# SERVICE TIPS

GAME: "QIX"

SUBJECT: GAME POWERS UP BUT WILL NOT COIN UP. BATTERY IS TOO LOW.

FIGURE 1

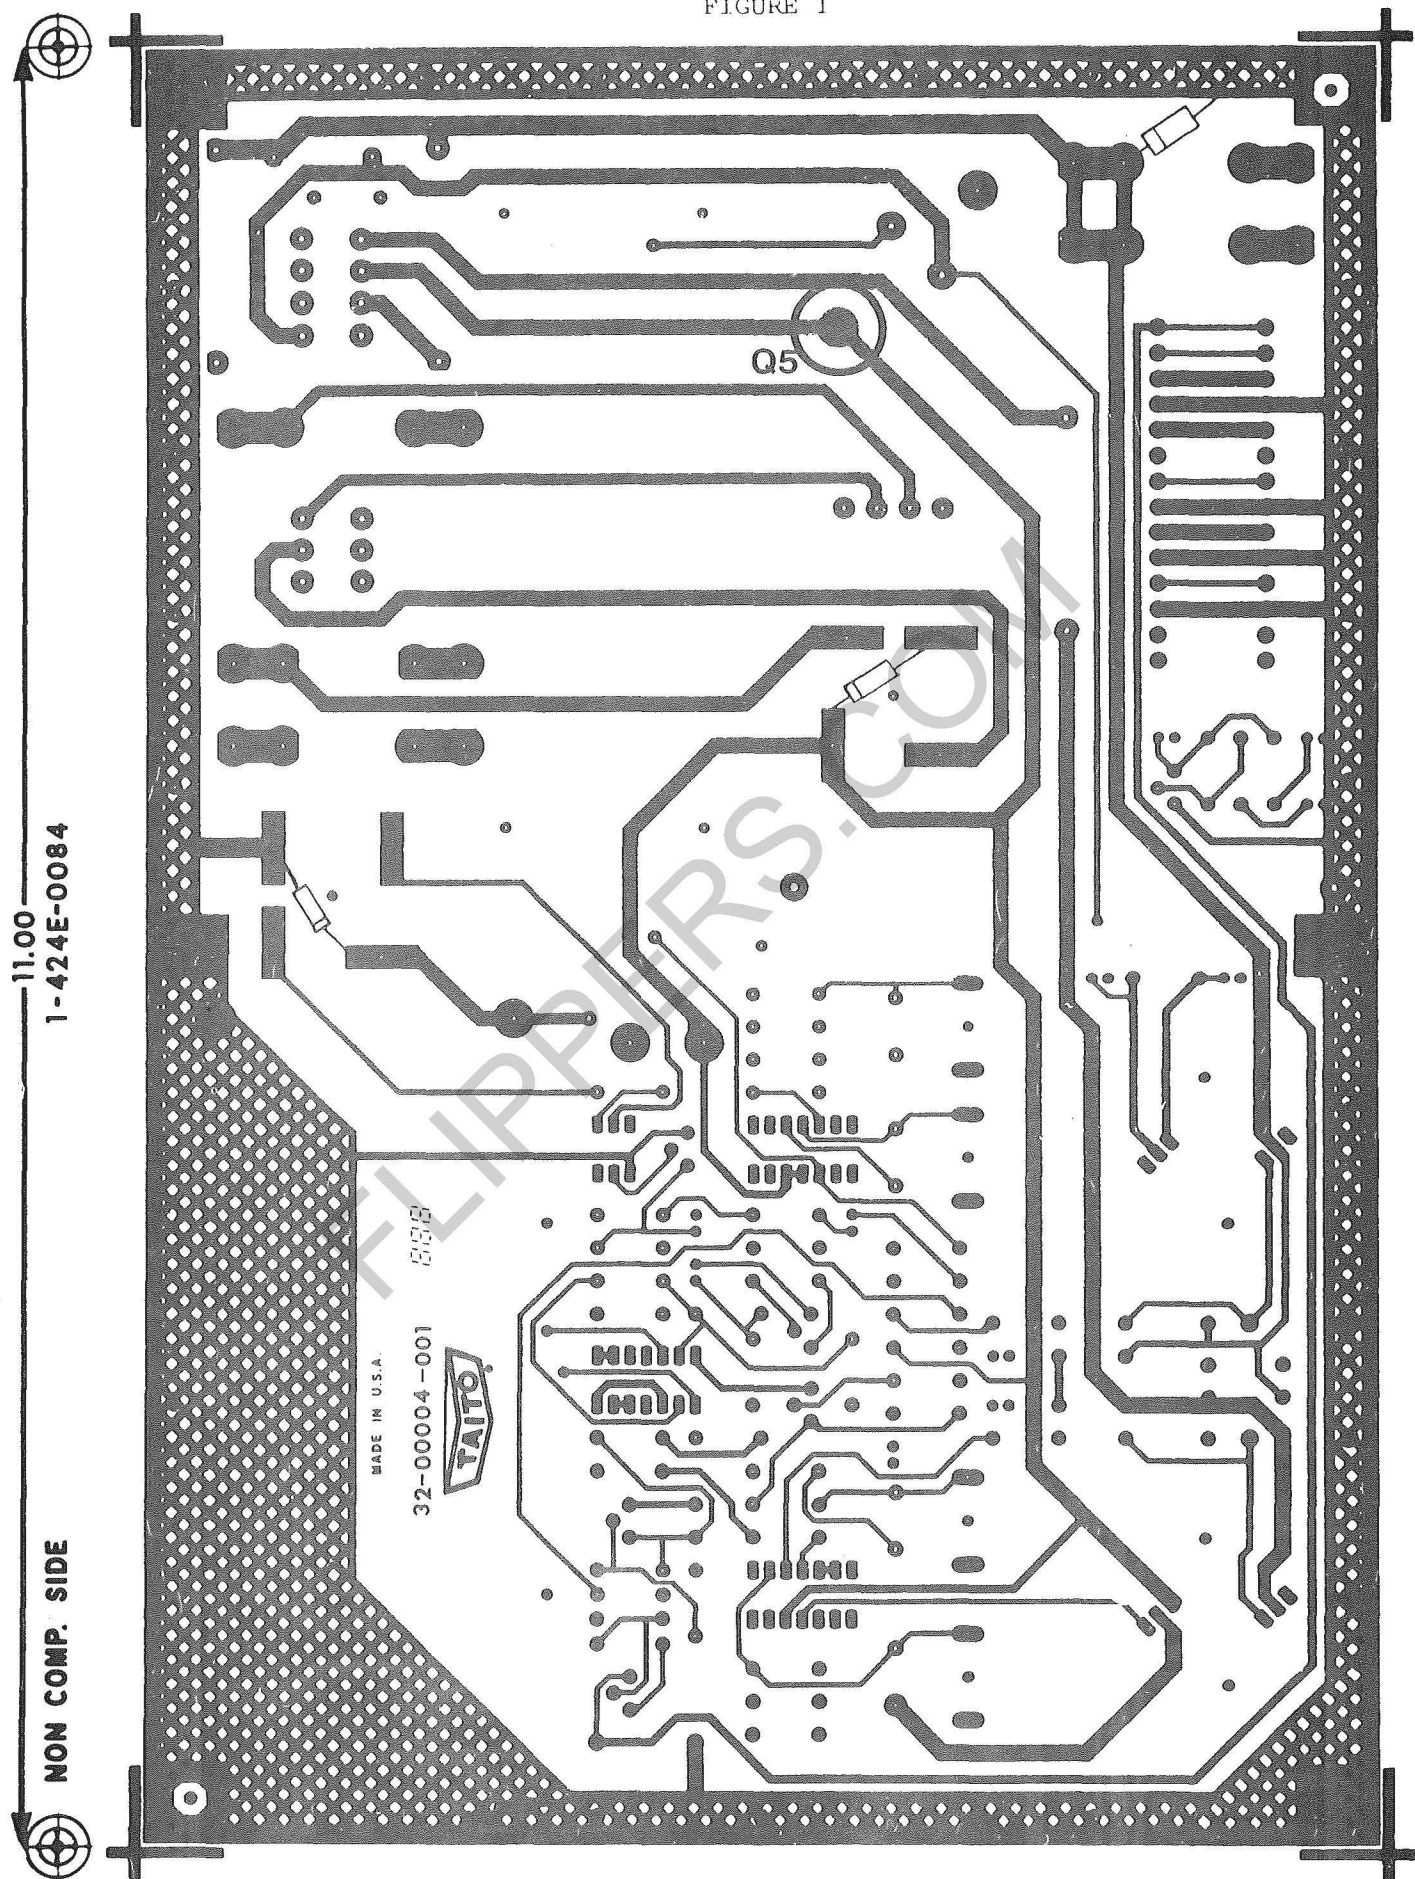
SUBJECT: POWER SUPPLY +5 VOLT PROBLEMS

SOLUTION: IMPROVE Q5'S CONNECTION ON POWER SUPPLY

PROCEDURE: REMOVE THE TWO NUTS AND BOLTS HOLDING DOWN Q5. ON THE ETCH  
SIDE OF THE BOARD (REFER TO FIGURE 1), SCRAPE THE GREEN SOLDER  
RESIST OVER THE FOIL AROUND THE SCREW PAD FOR Q5. WET THE  
PAD WITH SOLDER TO MAKE SURE THAT ALL SOLDER RESIST MATERIAL  
IS REMOVED. REPLACE NUTS AND BOLTS FOR Q5.

FIGURE 1

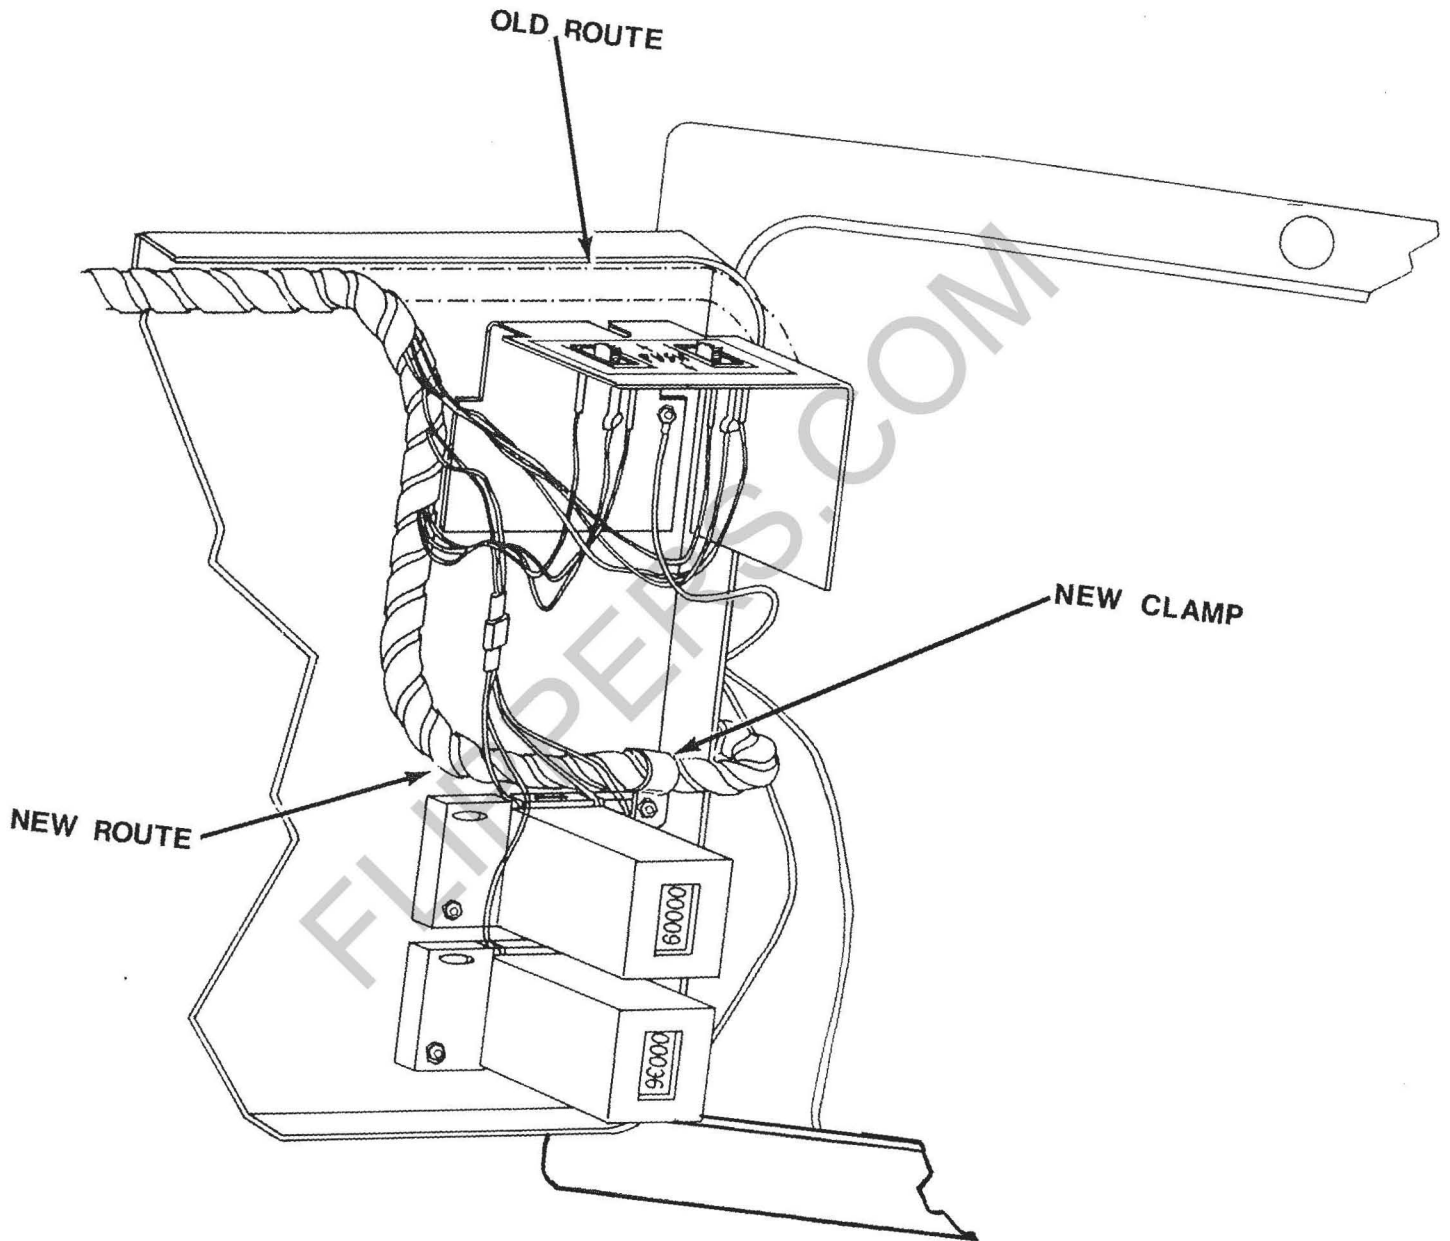
SUBJECT: COIN DOOR CABLE CAN GET PINCHED IN COIN DOOR FRAME.

SOLUTION: RE-ROUTING OF COIN DOOR CABLING AND ITS HARNESS AS FOLLOWS:

2. RE-ROUTE CABLE ON COIN DOOR AS FOLLOWS: (SEE FIG. 1 )

- A. SNIP WIRE TIE THAT HOLDS FLEXIBLE CABLE TO COIN DOOR (ABOVE SERVICE SWITCH BRACKET).

- B. RE-ROUTE CABLE TO THE LEFT OF AND UNDER THE SERVICE SWITCH BRACKET.
  - C. REMOVE UPPER RIGHT NUT FROM THE TOP COIN COUNTER.
  - D. REINSTALL NUT TRAPPING SMALL CABLE CLAMP (59-00004-004) AROUND COIN DOOR CABLE ON COIN COUNTER SO THE CABLE IS NOW POSITIONED HALF-WAY DOWN THE COIN DOOR HINGE.
3. REINSTALL CABLES AS FOLLOWS: (SEE FIG. 2 )
- A. REMOVE LOWER RIGHT SCREW ON INTERLOCK ASSEMBLY COVER.
  - B. REINSTALL SCREW, ANCHORING PREVIOUSLY REMOVED CABLE CLAMP AROUND COIN DOOR CABLE.
  - C. RECONNECT MOLDED CONNENCTORS FOR COIN DOOR CABLE.
  - D. VERIFY THAT CABLE FREELY MOVES THROUGH CABLE CLAMP UNDER INTERLOCK ASSEMBLY COVER, TO PREVENT PINCHING THE CABLE.

FIGURE 1

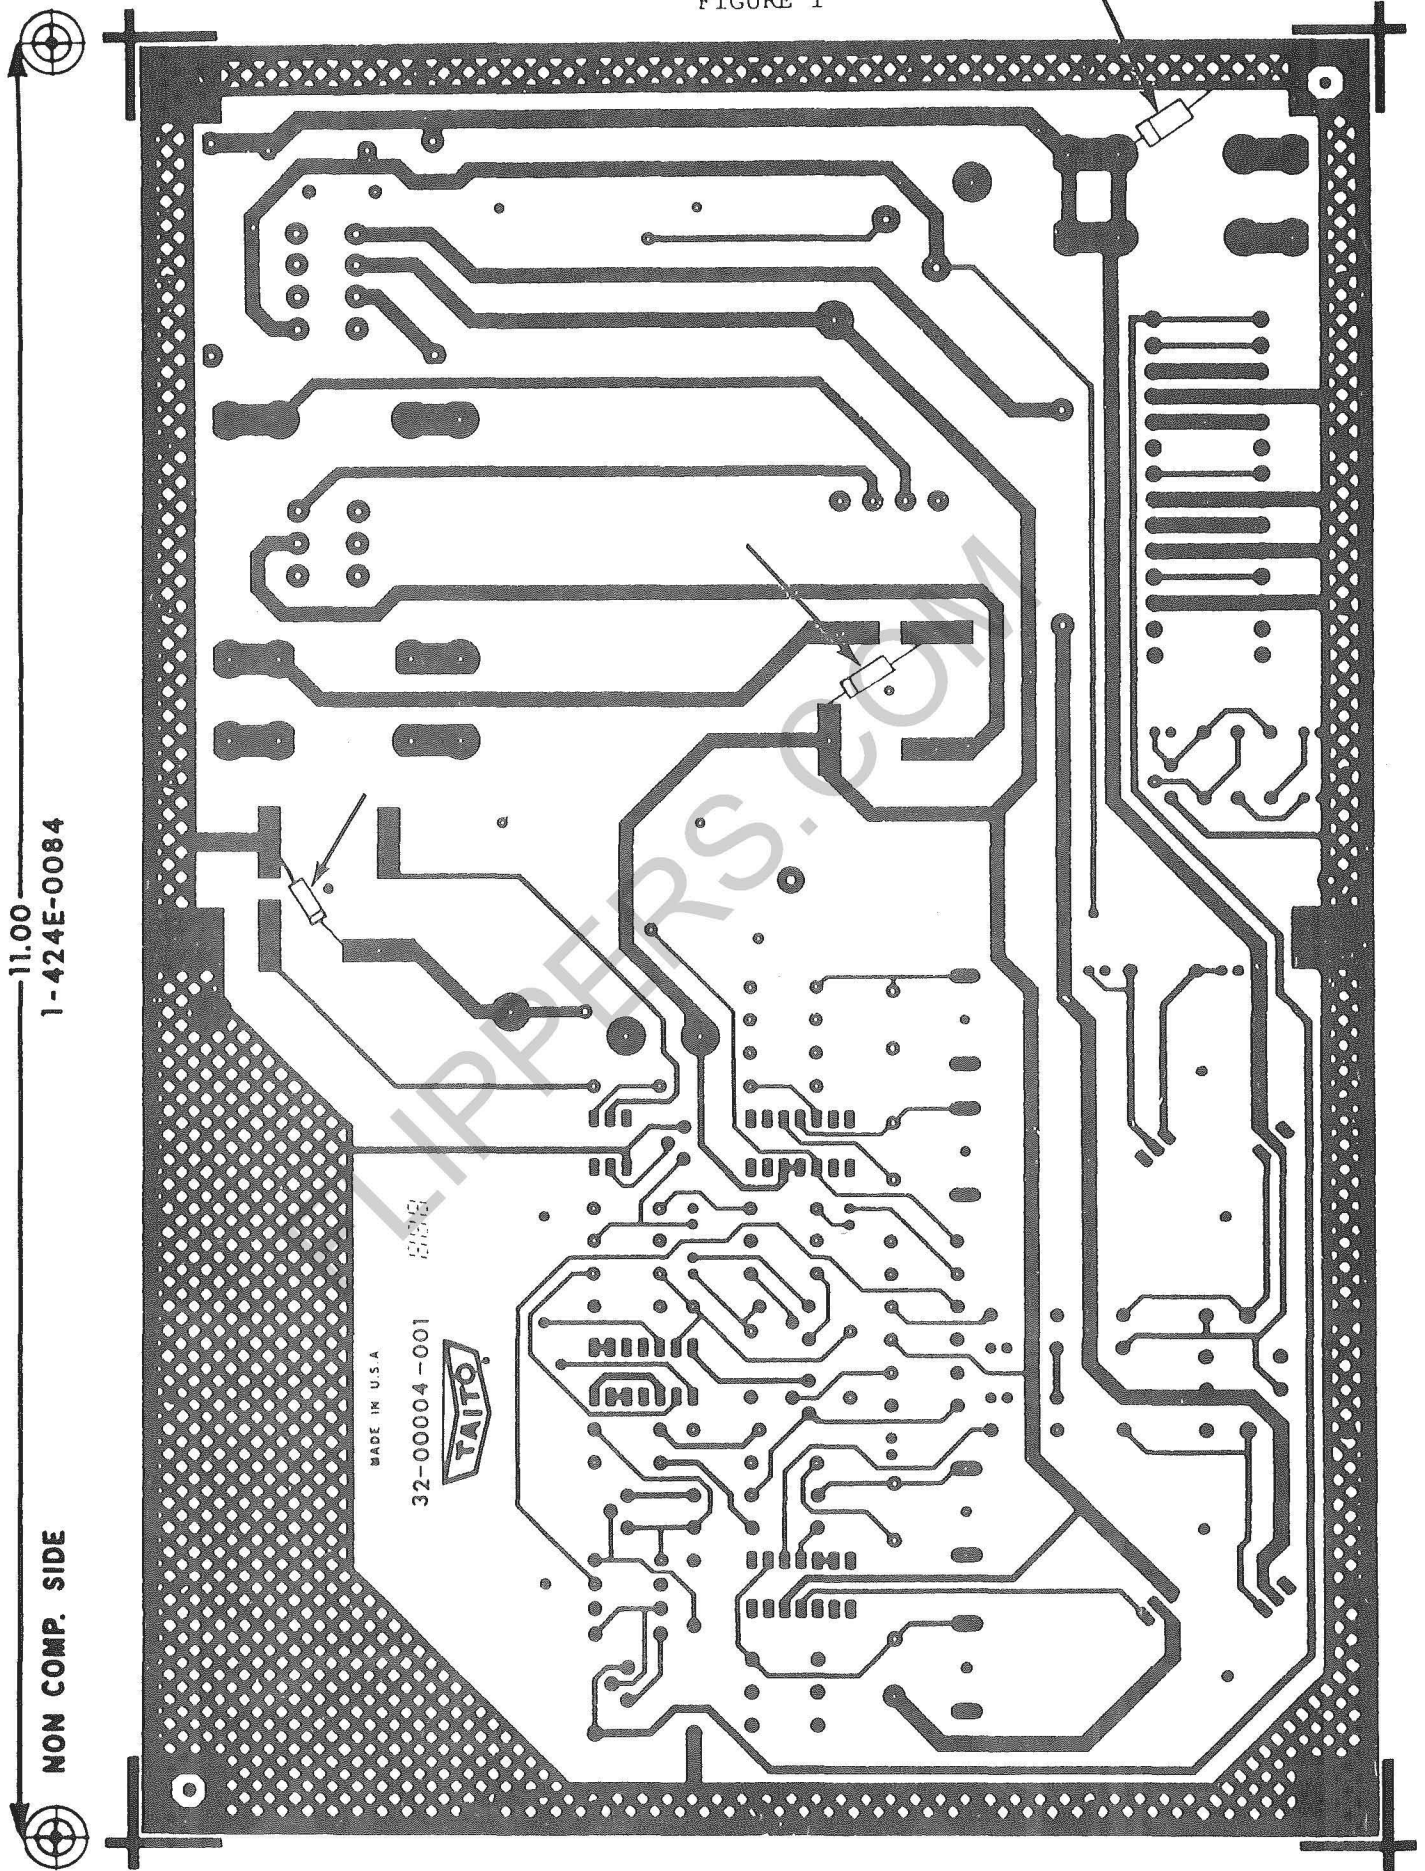
ANY TIME THAT "BR1" (BRIDGE RECTIFIER 1) IS REPLACED, THE FUSE  
HOLDER FOR F1 SHOULD BE RESOLDERED. WHEN INSTALLING A NEW BR1,  
ENSURE THERE IS AT LEAST 1/8 INCH CLEARANCE BETWEEN THE BOARD  
AND THE RECTIFIER. FAILURE TO DO SO MAY RESULT IN FURTHER F1  
AND/OR BR1 FAILURE.

THERE ARE COMPONENTS UNDER THE POWER SUPPLY THAT LOOK LIKE DIODES (REFER TO FIGURE 1 AND 2)(ON ISS. "C" OF THE POWER SUPPLY THEY ARE CALLED D13, D14, D17 AND ARE ON THE COMPONENT SIDE). THESE COMPONENTS ARE CALLED TRANSORBS. THEY ARE USED TO COMPENSATE FOR FLUCTUATING A.C. LINE VOLTAGES. MEASURING THEM OUT OF CIRCUIT, OTHER THAN CHECKING FOR SHORTS, IS USELESS. THE ONLY WAY TO TEST THEM IS TO TAKE THEM OUT OF CIRCUIT, AND THEN POWER UP THE POWER SUPPLY WITH A LOAD. IF THE VOLTAGE, AFTER ADJUSTMENT, IS CORRECT, THEN THE TRANSORB NEEDS TO BE REPLACED.

## FIGURE 2

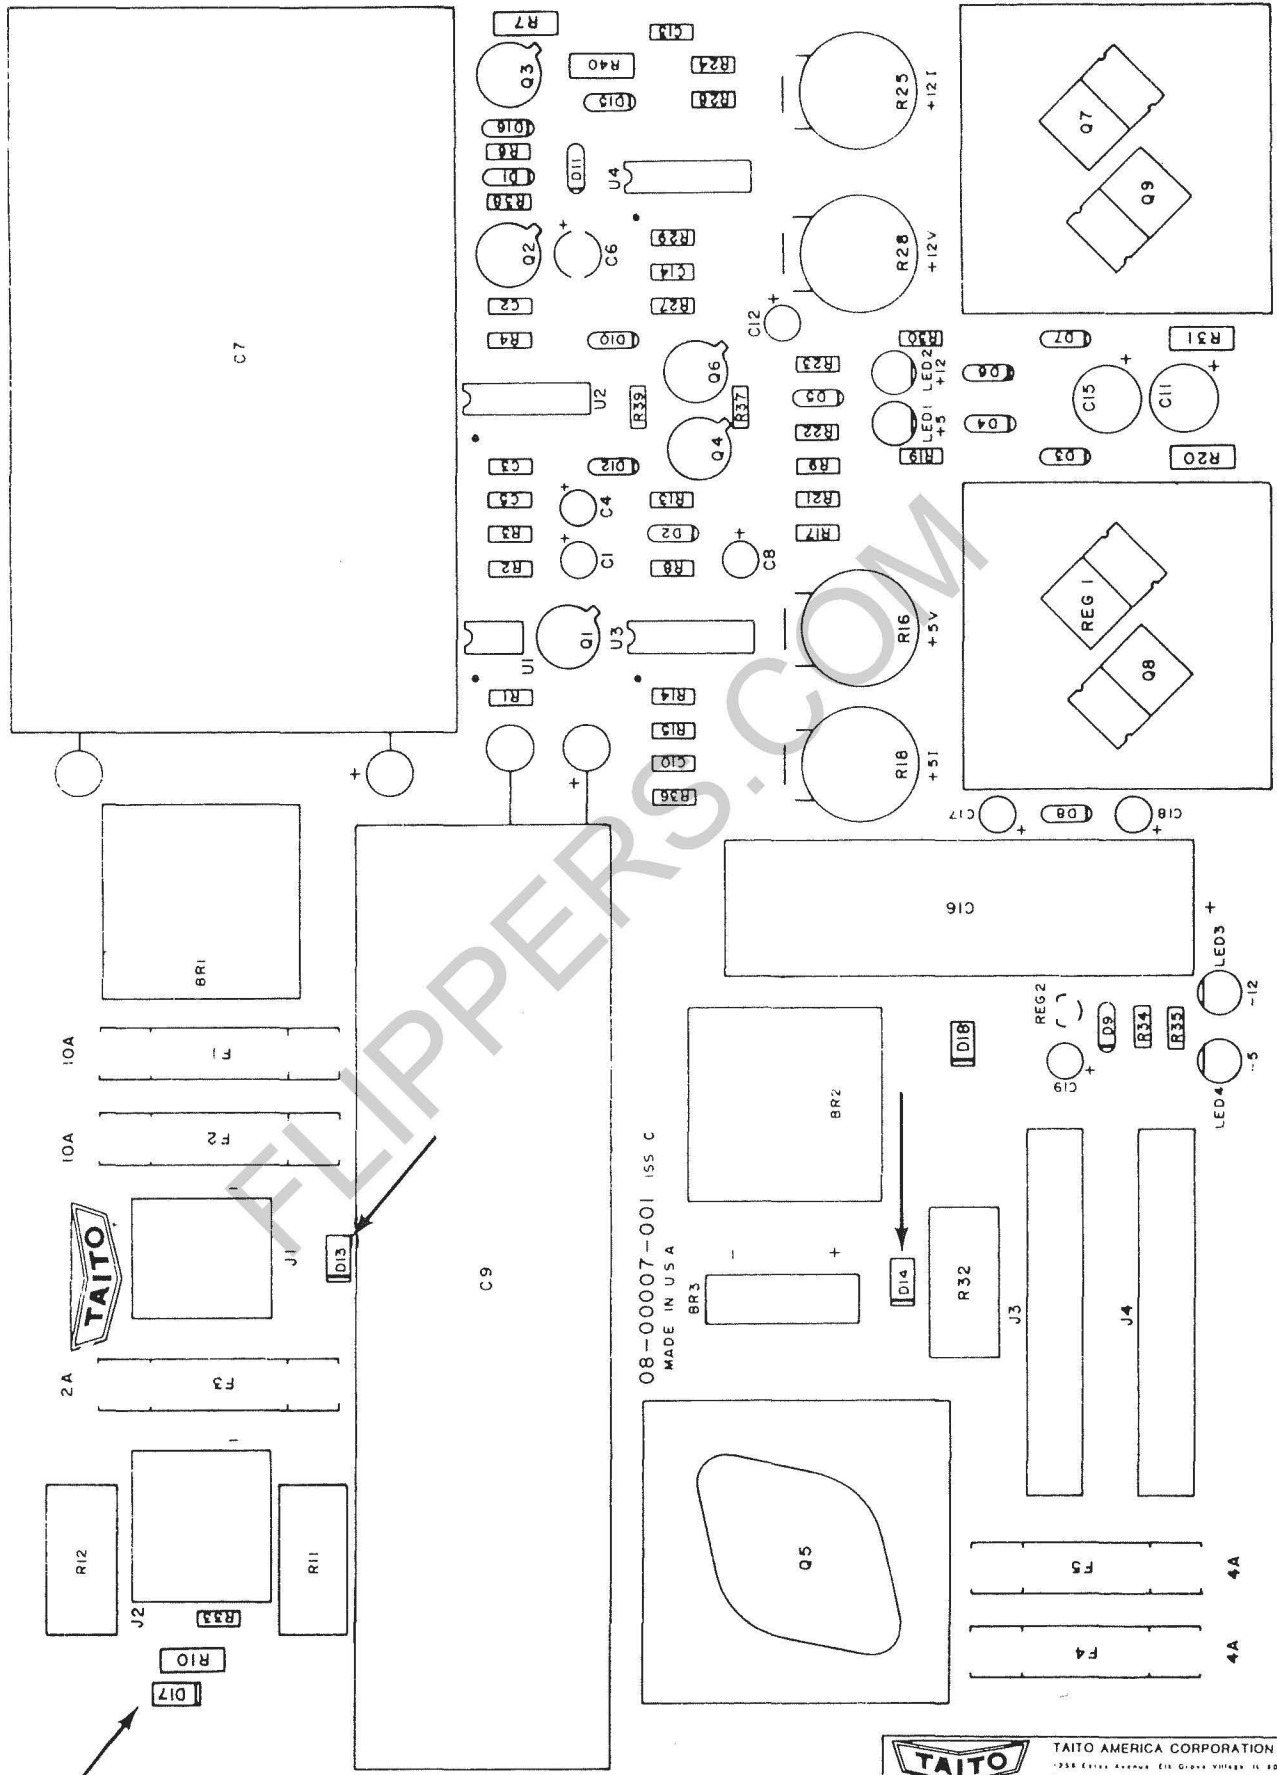
ENSURE THAT THE SCREWS ON C7 AND C9 (REFER TO FIGURE 2) ARE TIGHT. AFTER THE SCREWS ARE TIGHT, MEASURE, WITH THE METER IN AC VOLTAGE MODE, THE OUTPUT OF +5V. THE RIPPLE SHOULD BE LESS THAN A QUARTER OF A VOLT (0.25 V). IF NOT, C7 COULD BE THE PROBLEM.

IF THE +5 VOLTS OUTPUT IS LESS THAN 0.7 VOLTS, MEASURE THE PLUS SIDE OF C7. THERE SHOULD BE AT LEAST +10 VOLTS D.C. IF IT IS LESS THAN 10 VOLTS, THEN ONE OF SIX THINGS COULD BE WRONG:

- 1) F1 IS BLOWN.
- 2) A.C. INPUT BETWEEN J1 PIN 1 & 2 IS LESS THAN 10 VOLTS AC.
- 3) BR1 IS WEAK.
- 4) THE TRANSORB FOR BR1 IS WEAK.
- 5) C8 IS SHORTED.
- 6) C7 IS SHORTED.
